Oliver Street-Bennett Street-Park Street bicycle route, Freshwater

Concept design road safety audit

NBC-PROJ-0008-01 CD RSA OLIVER-BENNETT REV 1

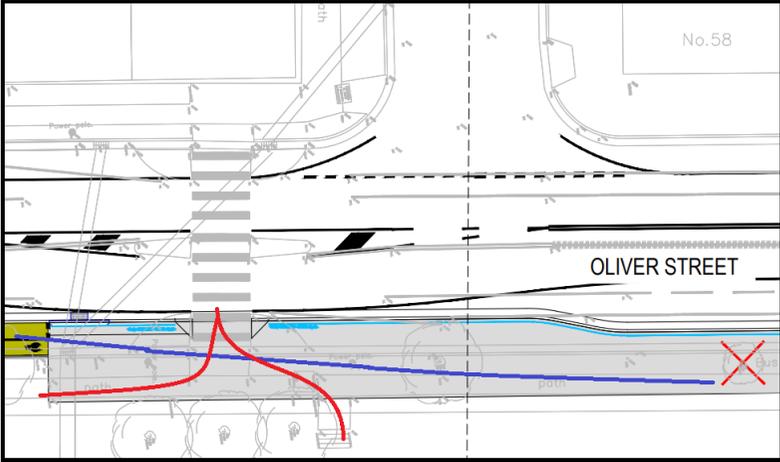
Ref	Location/ priority	Road safety audit finding	Priority
1	North-eastern corner of the Oliver Street/ Brighton Street intersection.	<p>The left-hand image shows the proposed layout of the pedestrian-bicycle crossings over Oliver Street and Brighton Street as well as the two-way cycleway extending to the north, along the western side of Oliver Street. The relative arrangement of the zebra stripes (marking the pedestrian crossing) and the green coloured paving (marking the bicycle route) creates an unnecessary cross over conflict as shown, between pedestrians and cyclists. This could result in <i>bicycle-pedestrian</i> crashes.</p> <p>The right-hand image shows a simple revision to the design which has switched the relative positions of the zebra markings and the green coloured bicycle crossing over the Brighton Street eastern leg of the intersection. This simple revision is more likely to reduce the need for pedestrian and bicycle cross over movements.</p> <p>Note: In each diagram, the blue line represents the bicycle travel path and the red line represents the pedestrian travel path.</p>  <p>Left: The relative positions of the zebra markings and the green coloured bicycle paths would create an unnecessary cross over conflict between these two users as shown. Right: By switching the relative positions of the zebra markings and the green coloured bicycle crossing in the Brighton Street eastern leg, this could reduce the degree of conflict between the two road user groups.</p>	Medium

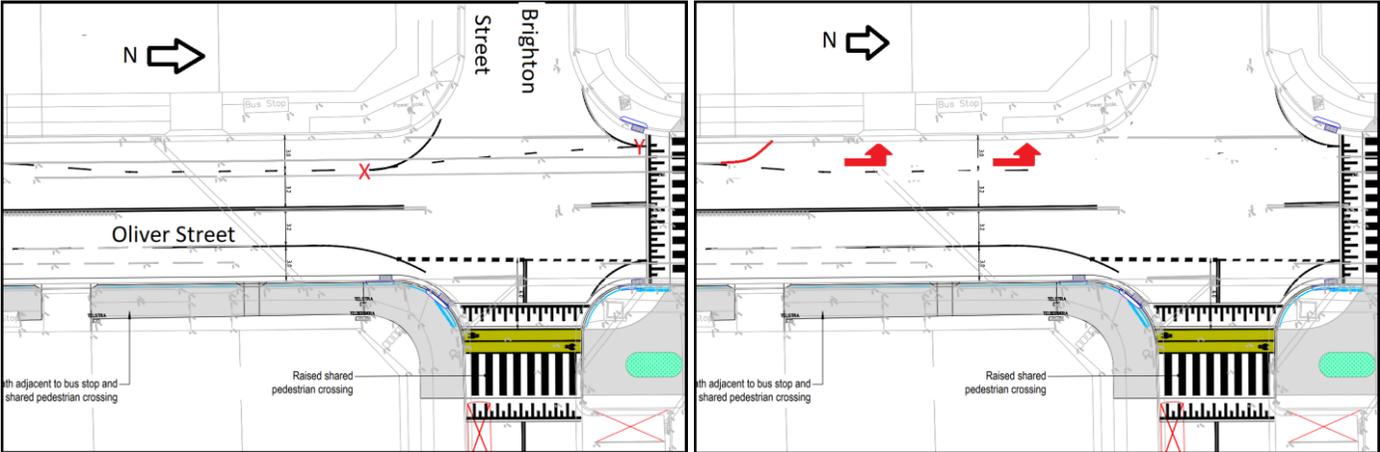
Ref	Location/ priority	Road safety audit finding	Priority
2	<p>General – Implications of pedestrian-bicycle crossings in side roads which are close to the intersection with Oliver Street.</p> <p>NB. Although the Oliver Street/ Brighton Street intersection is used as the example in the diagrams, this issue and the stated risks should be considered at ALL crossings over minor road legs to intersections.</p>	<p>The design proposes several pedestrian-bicycle crossings in the side roads stemming off Oliver Street. In general, these are offset 6m from the hold lines of the intersection. The audit team notes the following concerns and crash conflicts:</p> <ul style="list-style-type: none"> ▪ Any vehicles stopped at the hold lines may generate queuing and queue spillback over the crossing as shown in the left-hand image (row of green cars). This may block the crossing which therefore has several reactive risks by pedestrians and cyclists, as follows: <ul style="list-style-type: none"> ▪ Pedestrians-cyclists that cross from the far side of the crossing (movement 1) may become trapped on the road and unable to complete the crossing due to the queued vehicles. This could prolong their presence on the road, and increase exposure to impacts by other vehicles. ▪ Pedestrians-cyclists from the near side of the road may attempt to cross between or behind queued traffic (movement 2). This is dangerous as these crossing road users may be hidden from the view of other drivers, such as (in this case) the northbound right-turning vehicle marked as movement 3. ▪ Any vehicles that turn into the side road may not expect to encounter a crossing this close to the intersection, nor the need to stop in response to a crossing road user. Using the left-hand image, the northbound right-turning driver (movement 3) would tend to look to the north to judge for gaps in the southbound <i>through</i> traffic stream. By doing so, they may fail to observe the conditions in the Brighton Street departure including the crossing, and any crossing road users. This could lead to a <i>right-turn on pedestrian/ bicycle</i> crash. Also, if they accept a substandard gap in the southbound traffic stream, they may tend to accelerate hard when making the turn, only to be faced with the immediate need to slow down and/or stop. Most drivers tend to accelerate when departing from an intersection. ▪ Even if the eastbound departing vehicle stops in response to crossing pedestrian-bicycle (green car in the right-hand image), this could leave them exposed to impacts by other vehicles (eg. purple vehicle), especially if they extend back into the control area of the intersection. ▪ In most cases, the hold line was not in line with the projection line of the kerbs either side of the intersection. Using the left-hand image, the first green vehicle at the head of queue has stopped clear of the hold line, but would still be exposed to impacts by southbound vehicles on Oliver Street due to the lack of protection from the kerblines. <div style="display: flex; justify-content: space-around; align-items: flex-start;"> <div style="text-align: center;">  </div> <div style="text-align: center;">  </div> <div style="width: 30%; padding-left: 20px;"> <p>Left-hand image: If a vehicle in the side road stops at the hold line, it could generate a queue which extends over and blocks the pedestrian-bicycle crossing.</p> <p>Right-hand image: If a vehicle entering the side road (green vehicle) stops in response to a crossing road user (yellow dot), this could leave the green vehicle exposed to impacts by other vehicles (eg. purple vehicle).</p> </div> </div>	Medium

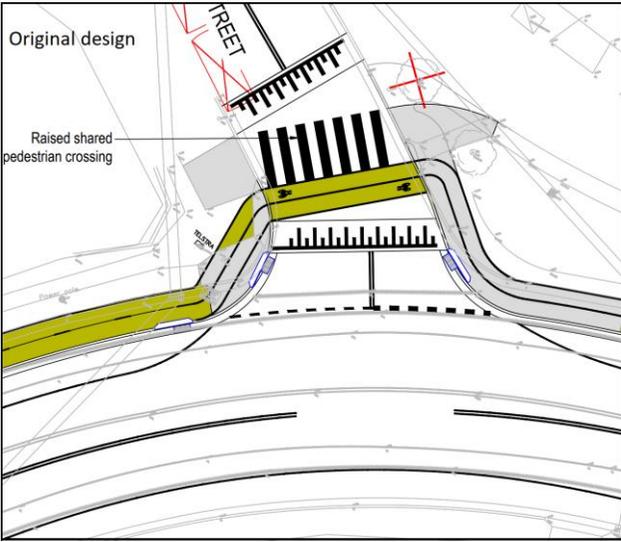
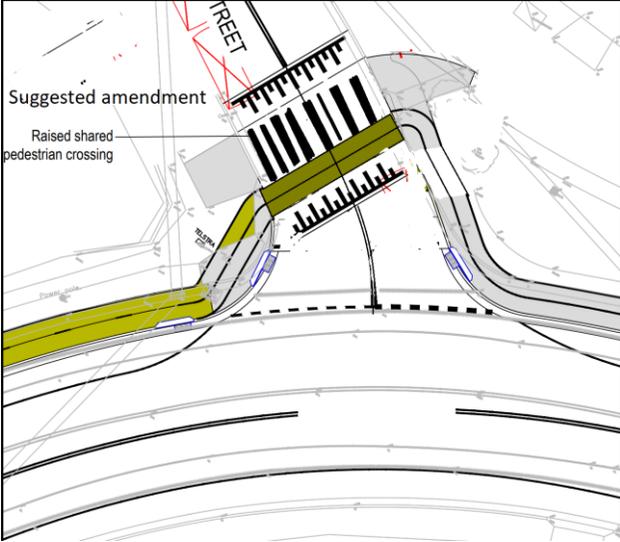
Ref	Location/ priority	Road safety audit finding	Priority
4	Oliver Street roundabouts with Wyndora Avenue and Soldiers Avenue.	<p>The Oliver Street intersections with Wyndora Avenue and Soldiers Avenue are both roundabouts. Under the proposed design, these will both contain pedestrian-bicycle crossings over the eastern leg, which is in the immediate approach-departure to the roundabout. Item 2 discussed the risks associated with having crossings too close to priority control points. These included risks of queues from the intersection spilling back over the crossing, or alternatively, queues from the crossing spilling back into the intersection. The issues described in item 2 would all persist with the two roundabouts at the Wyndora Avenue and Soldiers Avenue intersections. Furthermore, drivers departing into the eastern legs may have even less expectation of the crossing (and crossing pedestrians and cyclists) compared with non-roundabout intersections. This is because of the circular path driven by drivers, especially in right-turn movements. As shown below, a right-turning driver would need to negotiate a 90-degree turn through a circulating path. This would also involve sight lines in the forward view which would be, for most of the time, angled well away from the subject crossing. Drivers also tend to accelerate when departing roundabouts, and most drivers do not expect to encounter situations that require them to stop this soon after departing from a roundabout.</p> <p>Although the Wyndora Avenue intersection is shown below, this issue also applies to the Soldiers Avenue intersection.</p>  <p><i>Left: Drivers using the roundabout, especially right-turners would not expect to encounter a crossing or the need to stop this soon after departing from the roundabout.</i></p>	Medium

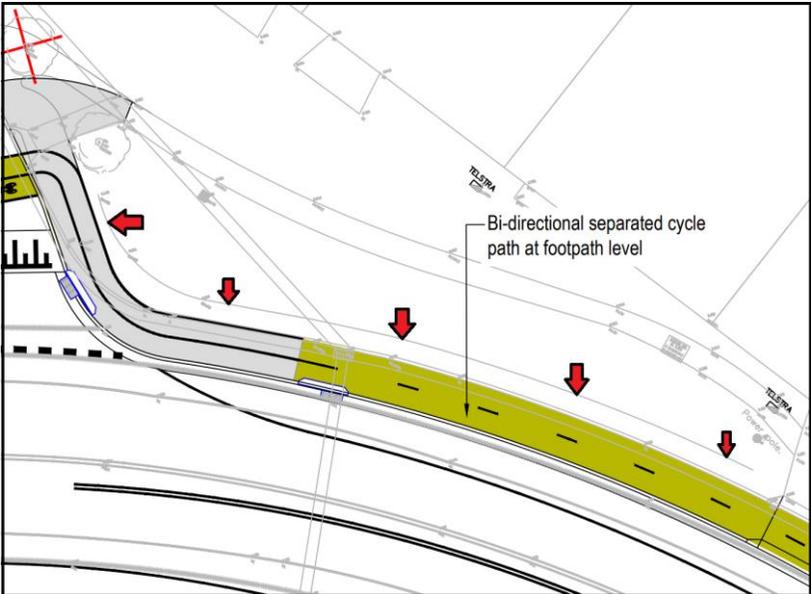
Ref	Location/ priority	Road safety audit finding	Priority
5	Bicycle movements at the Oliver Street/ Wyndora Avenue roundabout and the Oliver Street/ Soldiers Avenue roundabout.	<p>The project team should be mindful of the types of cyclists that are likely to, or expected to use the cycleway. Under current, pre-project conditions, these cyclists would be ones that travel on the road and adjacent to the northbound and southbound road traffic. As such, they would have a higher risk tolerance and would tend to be more competent cyclists compared with (say) recreational cyclists that would opt to use a shared path. In these respects, the re-distribution of these cyclists to the proposed cycleway may not perform as expected and some deviations from expected behaviour should be expected.</p> <p>Firstly, these cyclists may experience frustration and dissatisfaction in the level of service offered by the shared path portions of the project. In the pre-project scenario, these cyclists would have shared on road space with road vehicles and would enjoy faster travel times and less physical hinderances. In the post-project scenario, these same cyclists would need to negotiate kerb ramps; shared paths that may contain slow-moving or stationary pedestrians; bus loading/ unloading activity; and obstructions such as trees, signs, poles and bus shelters.</p> <p>Secondly, the crossings at the two roundabouts are “bent out” facilities requiring cyclists to deviate significantly from the otherwise straight line travel route. Rather than deviate this course to use the designated crossing, many of these cyclists may bypass the crossing altogether and use the roadway. The image below shows an example of this where the cyclist would use the kerb ramps to enter the road space, circulate the roundabout and then use the corresponding kerb ramp on the departure side to re-enter the downstream shared path. This puts them at unnecessary risk of impacts by other road vehicles. Also, there does not appear to be anything illegal about making this crossing (although a crossing in the reverse direction, whilst still being an equal temptation would at least be illegal due to the “wrong way” travel through the roundabout).</p> <p>In addition to the roundabouts, this “pick and choose” route-selection behaviour may also occur at various other locations along the route, especially when considering that these would have been cyclists that use the on-road facilities in the pre-project scenario.</p>  <p><i>Left: Cyclists may be tempted to bypass slower operating facilities such as shared paths and crossings that deviate from the otherwise “straight-line” travel route.</i></p>	Medium

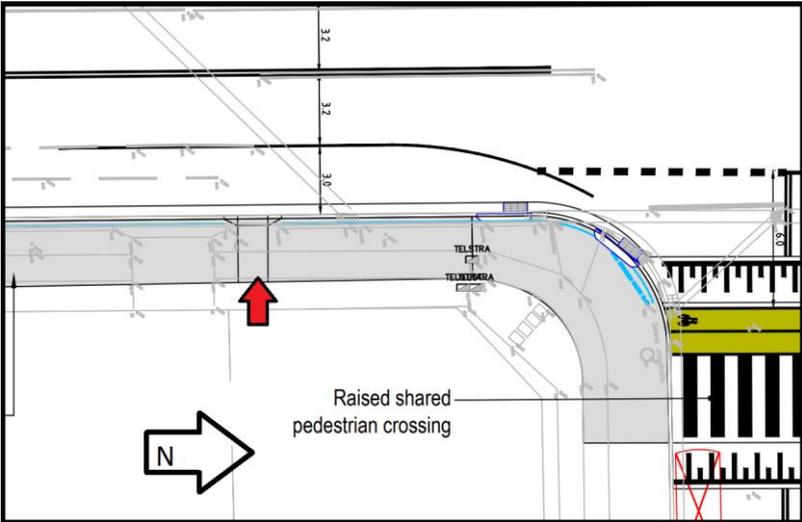
Ref	Location/ priority	Road safety audit finding	Priority
6	Zebra crossing over Oliver Street opposite Johnson Street and the shared path-cycleway interface	<p>Similar to item 1, there may also be a <i>bicycle-pedestrian</i> cross over conflict in the shared path on the eastern side of Oliver Street opposite Johnson Street. As shown below, the shared path will interface with a cycleway and pedestrian-exclusive footpath to the south. The shared path would allow co-mingling of pedestrians and cyclists. However, as a cyclist heads southbound, they would tend to shift to the west to access the cycleway as per the blue line. By contrast, any pedestrians emerging from the zebra crossing and also heading south would tend to move to the east to access the footpath. This would create a cross over conflict at this point. There may also be other cross over conflicts such as with pedestrians crossing the shared path to access the park.</p> <p>Whilst some degree of cross over conflict would always arise at such shared path interface points with cycleways, there may be merit in shifting this interface point further away from high-use facilities such as zebra crossings. The zebra crossing presents an obvious drainage point for pedestrians and the cross over and interaction with cyclists is almost inevitable given the close distance away from the cycleway.</p>  <p><i>Left: There is a cross over conflict create due to the transition from shared path to cycleway, and the close proximity to the zebra crossing.</i></p>	Medium
